TRANS/WP.29/GRSP/2001/14/Rev1
22 November 2001

PROPOSAL FOR DRAFT 06 SERIES OF AMENDMENT TO REGULATION No. 14
(Safety-belt anchorage)

Transmitted by the Expert from France

Figure 1 : Static force application device (S-FAD), isometric views

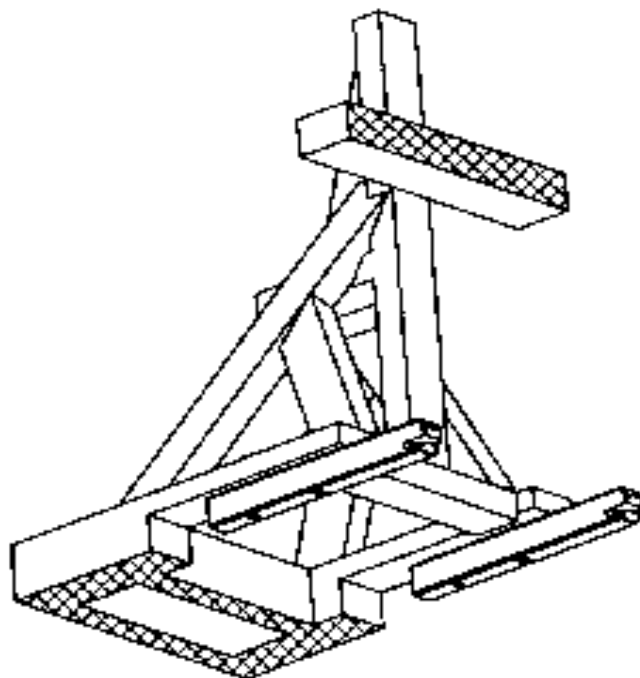
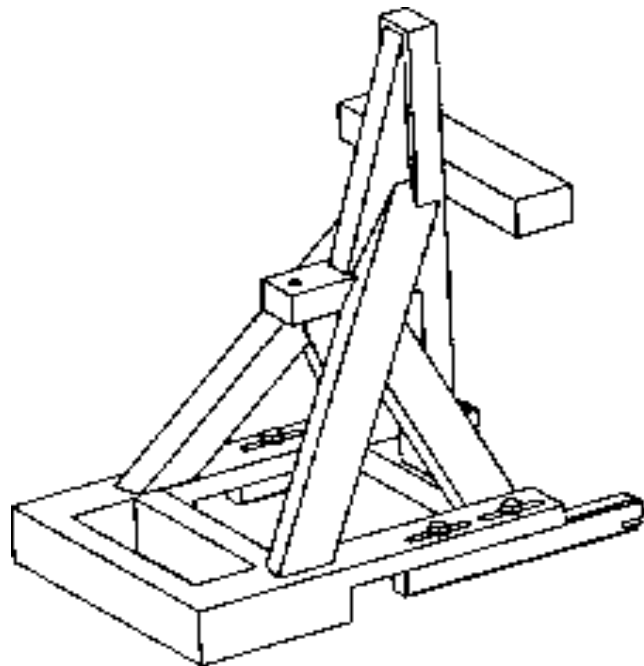
2.22. "Static force application device (S-FAD)" means a test fixture that engages the vehicle ISOFIX anchorages systems and that is used to verify their strength and the ability of the vehicle or seat structure to limit the rotation in a static test. The test fixture is describe in the figures 1 and 2.

The S-FAD is made of steel, mild steel rectangular tubing 50 mm by 75 mm of 3 mm nominal thickness, with 6 mm thick force application test device attachment point plate. Securely welded construction.

Figure 2 : Static force application device (S-FAD), dimensions

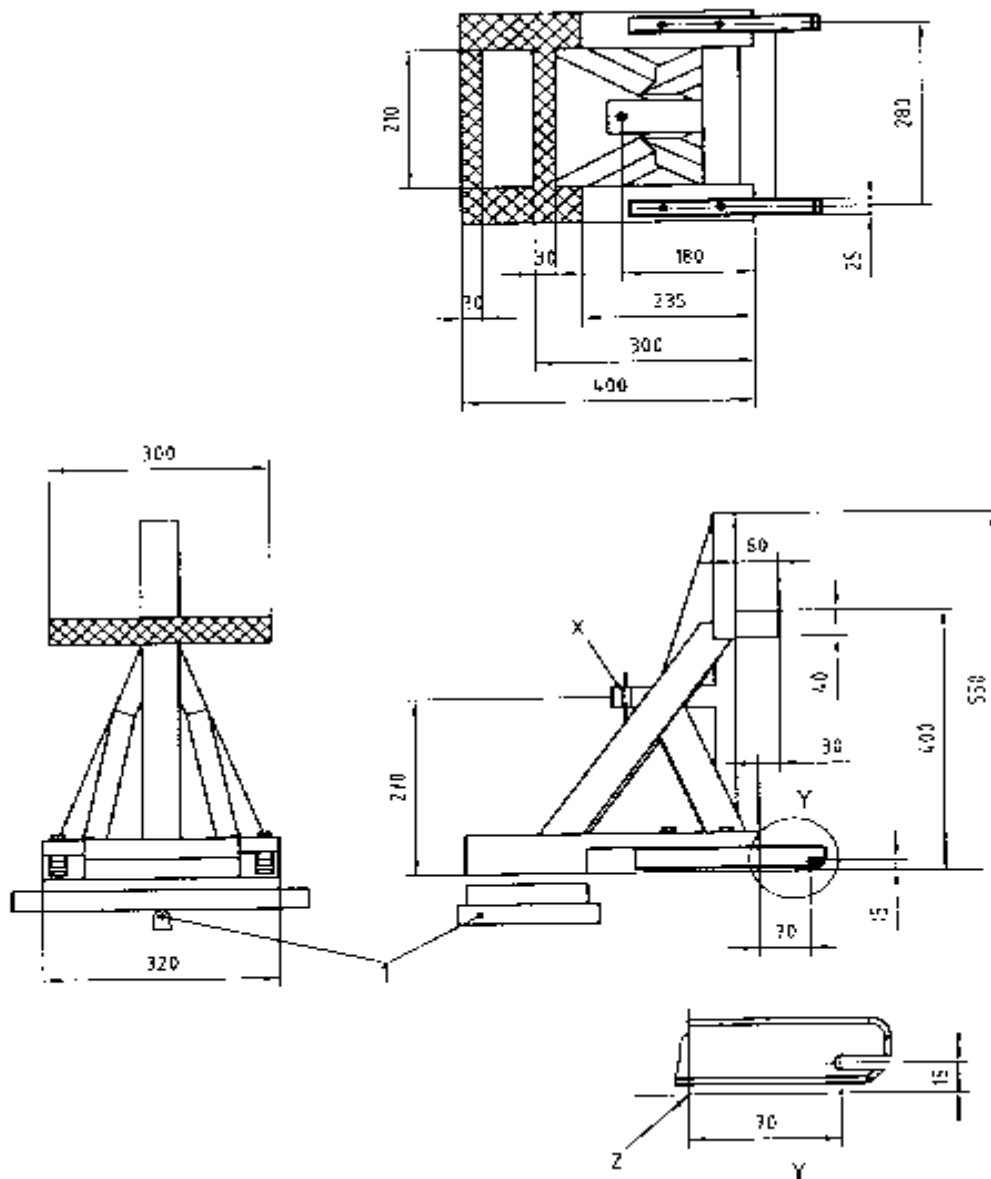
Stiffness of S-FAD : When attached to rigid anchorage bar(s) with the front cross member of the S-FAD supported by a rigid bar that is held at the centre by a longitudinal pivot 25mm below the S-FAD base (to allow bending and twisting of the S-FAD base) the movement of point X shall not be greater than 2 mm in any direction when forces are applied in accordance with table n°1 of paragraph 6.6.4. of this regulation. Any deformation of the ISOFIX anchorages system shall be excluded from the measurements

(e.g. the stiffness requirements will be fulfilled when using a securely welded construction consisting of rectangular 3mm steel tubing, and 6mm thick load application plate).

Figure 3 : ISOFIX Top tether connector (hook type) dimensions

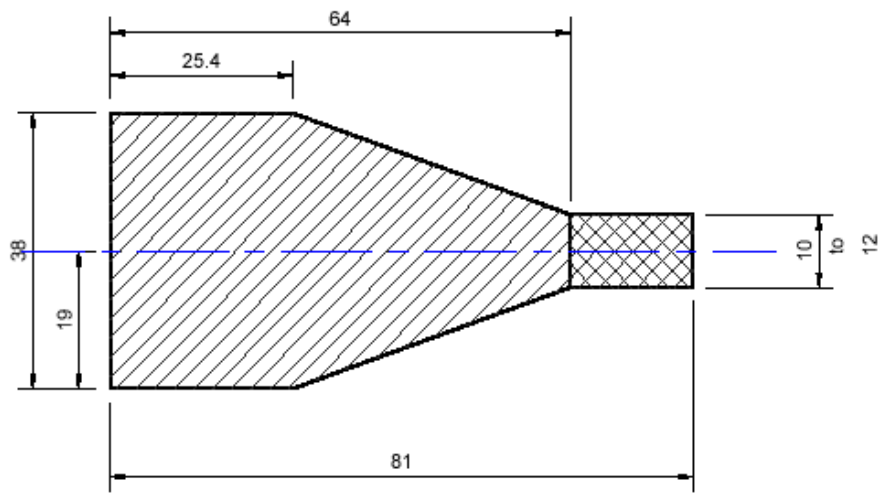
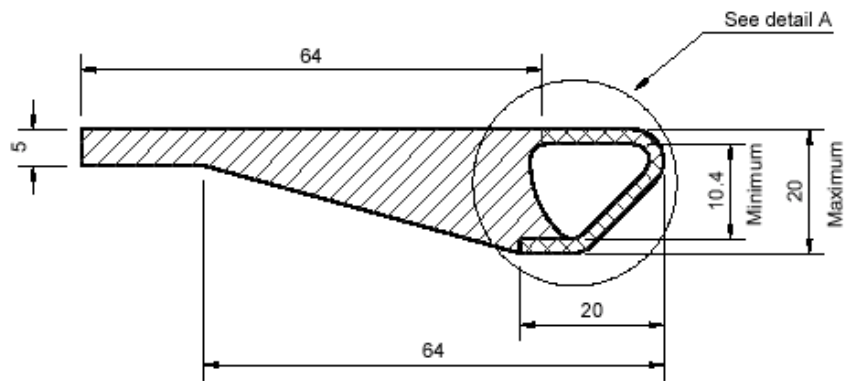
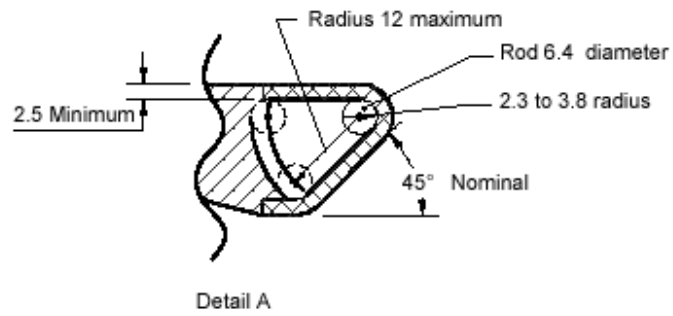
2.25. "ISOFIX top tether hook" means a top tether connector typically used to attach a top tether strap to a top tether anchorage as defined in figure 3."

Figure 4 : Distance between both low anchorage zones

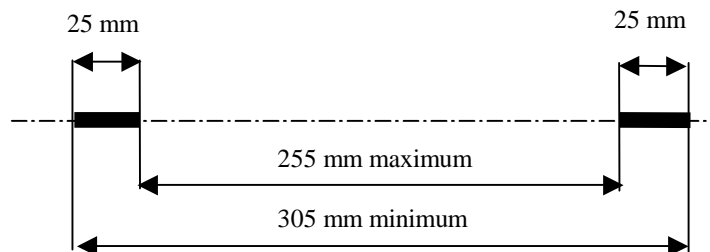
5.2.3.1. Any ISOFIX anchorages system shall be 6 mm ± 0,1 mm diameter transverse horizontal rigid bar(s) which cover(s) two zones of 25 mm minimum effective length located on the same axis as defined in figure 4.

Figure 5 : ISOFIX Top tether anchorage location, ISOFIX zone - Side view

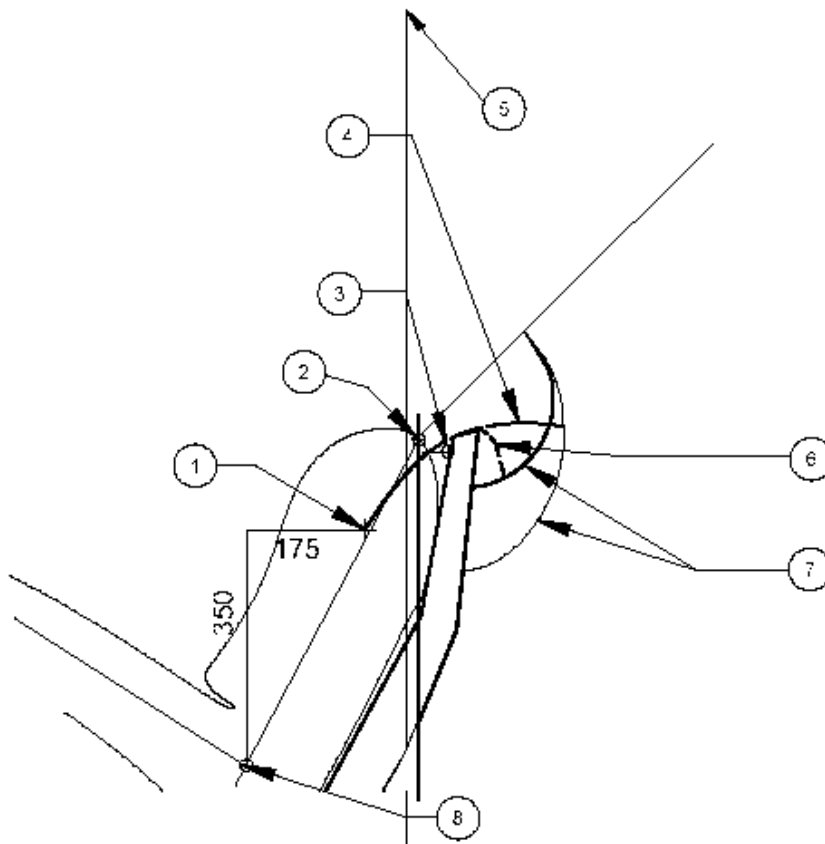
5.2.4.1. Subject to 5.2.4.3. the portion of each top tether anchorage that is designed to bind with a top tether connector shall be located within the shaded zone - as shown in figure 5 to 10 - of the designated seating position for which it is installed, with the reference of a template described in annex 4 of this Regulation, if,

Figure 10 : Alternative method of locating the top tether anchorage using the ISOFIX Child Restraint Fixture, ISOFIX zone - Side and plan views

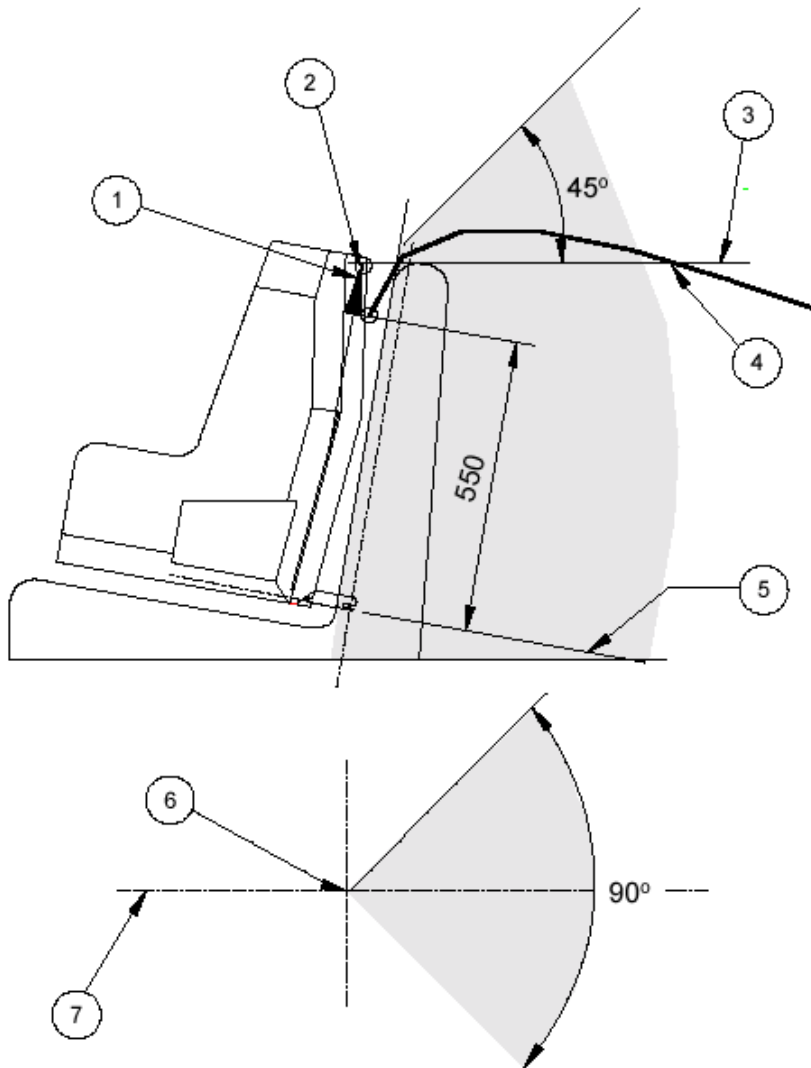
5.2.4.2. The ISOFIX top tether anchorage zone may be alternatively located with the aid of the Fixture "ISO 2", as defined in Regulation 16, in an ISOFIX position equipped with ISOFIX low anchorages as shown in figure 10. In the side view, the top tether anchorages shall lie behind a lateral plane containing the Fixture "ISO 2" vertical reference line and probe and below a lateral plane passing through the intersection of the "ISO 2" fixture reference line and the

plane containing the underside of the seat top bar, and extending rearward at an angle of 45° above the horizontal.

In the plan view, the top tether anchorage zone shall lie between the planes extending rearward and laterally from the tether reference point, and separated by an angle of 90°. Further, the ISOFIX top tether anchorage shall be more than 200 mm but not more than 1000mm from the origin of the top tether strap on the rear face of the "ISO 2" fixture, measured along the strap when it is drawn over the seat back to the anchorage.
